GTR #13 (Phase 2)

Recommendations for Test Procedures Task Force 3 Status

Livio Gambone
October 2020

Conformable Tank Subgroup: Definitions Proposal

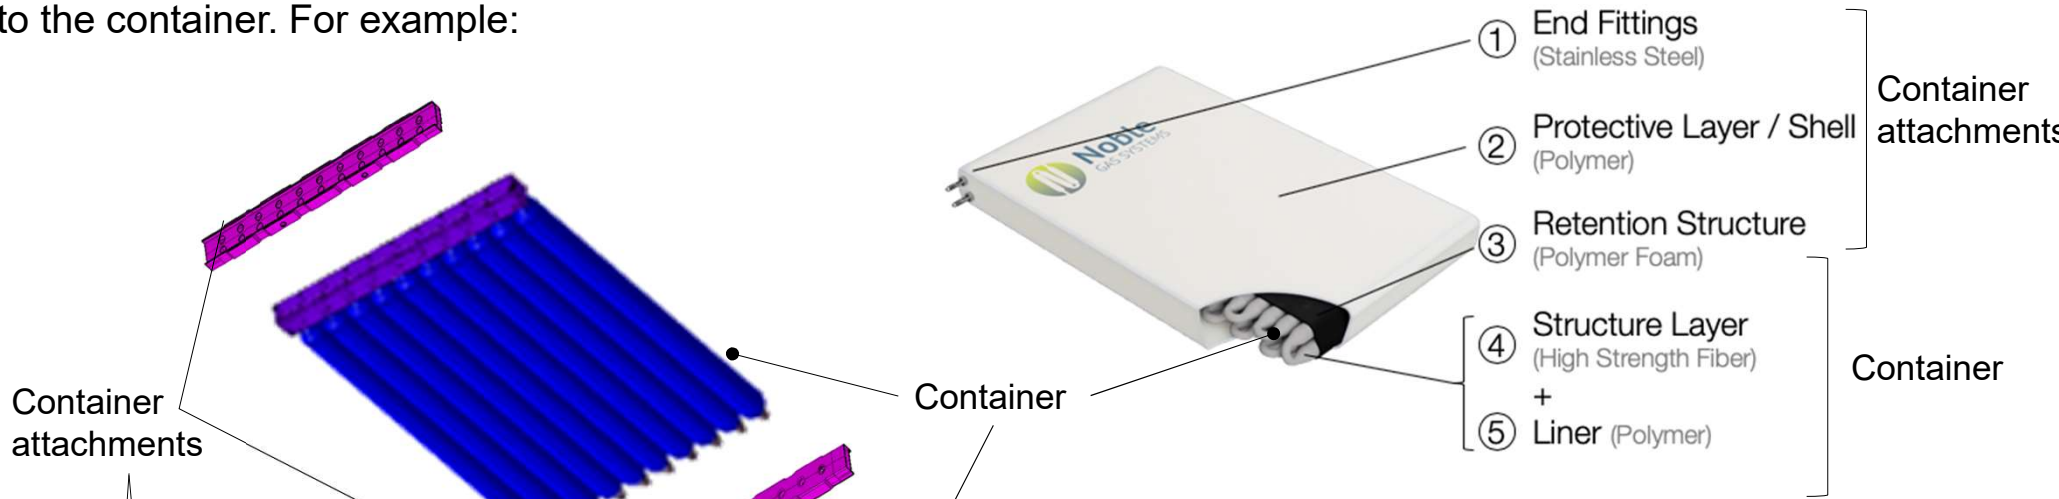
GTR 13 Phase 1	CT Subgroup proposal	Comments
<p>3.6 “Container” (for hydrogen storage) is the component within the hydrogen storage system that stores the primary volume of hydrogen fuel.</p>	<p>3.6 "Container" means the component of the vehicle that forms the primary volume for hydrogen fuel storage in a single chamber or in multiple permanently interconnected chambers. * Two or more chambers connected by high pressure piping are subject to the requirements in this regulation with their assembled form as a single container or CHSS.</p> <p>3.x “Container Attachments” means non-pressure bearing parts directly attached to the container. Container attachments provide additional support and/or protection to the container.</p>	<p>Container attachments will be clarified further in the document to provide the description of what is considered a container attachment and to differentiate them from hardware needed for vehicle mounting.</p> <p>Container attachments are part of the CHSS and therefore they are to withstand test.</p> <p>Clarification could be included in: -C. Description of typical hydrogen-fueled fuel cell vehicle (HFCVs) -3. Hydrogen storage system -(a) Compressed hydrogen storage system (17 or 18)</p>

<p>3.29 "Hydrogen storage system" indicates a pressurized container, pressure relief devices (PRDs) and shut off device that isolate the stored hydrogen from the remainder of the fuel system and the environment.</p>	<p>3.29 "Compressed hydrogen storage system (CHSS)" means a system designed to store compressed hydrogen fuel for a hydrogen-fuelled vehicle, composed of a container, container attachments (if any), and all closure devices (such as shut-off valve, check valve, and TPRD) required to isolate the stored hydrogen from the remainder of the fuel system and the environment.</p>	<p>A FCV may have one or more CHSS and some of them may be identical</p>
